# Office Action Summary

09/982,928

KNOWLES, STEVEN M.

### **DETAILED ACTION**

FIG. 9  
Prior Art

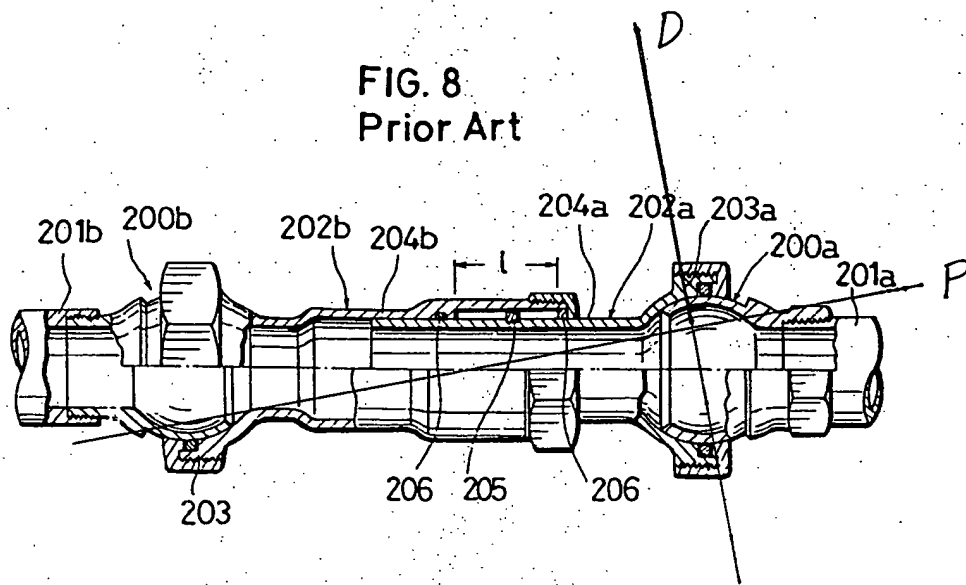
Regarding claims 1, 11 and 12, Sato discloses (figs.8 and 9) a flexible joint assembly for conducting a fluid, comprising: a joint assembly inlet (201a); a joint assembly outlet (201b); and a fluid flow path between the inlet and the outlet, the fluid flow path including: a first pivot joint (200a, 203a); a second pivot joint (200b, 202b); and a central fluid conductor (204a) fluidly coupling the pivot joints, wherein the pivot joints together appear (A) to be capable of providing greater than 60° bend between the inlet and the outlet. Sato does not explicitly state that the pivot joints together provide greater than a 60° bend; however, a greater than 60° bend (A) is within the scope of Sato's disclosure. Further, applicant is reminded that it has generally been recognized that the optimization of proportions in a prior art device is a design consideration within the skill of the art. In re Reese, 290 F.2d 839, 129 USPQ 402 (CCPA 1961). Therefore, it would have been obvious to one with ordinary skill in the art at the time the invention was made to optimize the proportion of the bend of Sato's pivot joints together to be greater than 60° as such practice is a design consideration within the skill of the art.

As to claim 7, Sato discloses (figs.8 and 9) the flexible joint assembly of claim 1 wherein the first pivot joint and the second pivot joint together appear (A) to be capable of providing a substantially 90° bend between the inlet and the outlet. Sato does not explicitly disclose the bend as being exactly 90°; however, a 90° bend is within the scope of Sato's disclosure. Further, applicant is reminded that it has generally been recognized that the optimization of proportions in a prior art device is a design consideration within the skill of the art. In re Reese, 290 F.2d 839, 129 USPQ 402 (CCPA 1961). Therefore, it would have been obvious to one with ordinary skill in the art at the time the invention was made to optimize the proportion of the bend of Sato's pivot joints together to be 90° as such practice is a design consideration within the skill of the art.

As to claim 21, Sato discloses (figs.8 and 9) a flexible joint assembly comprising: a joint assembly inlet (201a); a joint assembly outlet (201b); and a fluid flow path between the inlet and the outlet, the fluid flow path including: a first pivot joint (200a, 203a) configured to pivot about a first pivot (center of 200a); a second pivot joint (200b, 202b) configured to pivot about a second pivot (center of 200b); and a central fluid conductor (204a) fluidly coupling the first pivot joint and the second pivot joint, each of the first pivot joint and the second pivot joint including: an inner member (ball portion of 200a, 200b) having a dimension [a dimension (D) of any magnitude between zero and infinity—for instance a dimension equal to 4 times the diameter of the inner member) in a direction substantially normal to a path (any path (P) through 201a and 201b—not necessarily a fluid path) through each of the pivot joint assemblies' inlet and outlet; a receiving member (203, 203a) dimensioned to receive at least part of the inner member; and a sealing member (300) sealing the inner member to the receiving member at a distance (any distance—for instance a distance less than 14% of 4 times the diameter of the inner member) of less than 14% of a maximum dimension (D) from the respective pivot. The examiner notes that the limitations “a dimension (D)” and “a path” are claimed broadly enough to include virtually any magnitude and direction provided “a dimension (D)” is normal to “a path” and “a path” runs through the joint assembly inlet and outlet.

As to claim 27, Sato discloses (figs.8 and 9) the flexible joint assembly of claim 23 wherein each receiving joint member (203a, 202b): is coupled to one of the joint assembly inlet (201a) and the joint assembly outlet (201b); and defines a chamber in communication with the central fluid conductor (204a), the chamber being dimensioned to subsume an at least 115° arc (A) about the respective pivot.

The applicant argues that Sato does not disclose a bend of greater than 60° between inlet and outlet". This is not persuasive since figure 9 of Sato clearly shows (see marked-up copy) an angle (A) between the centerline of an inlet (201a) and the centerline of an element (202a) that appears to be well in excess of 60° and figure 8 shows that the element (202a) is capable of being positioned parallel to an outlet (201b). Therefore, the inlet is fully capable of forming an angle with the outlet in excess of 60°.
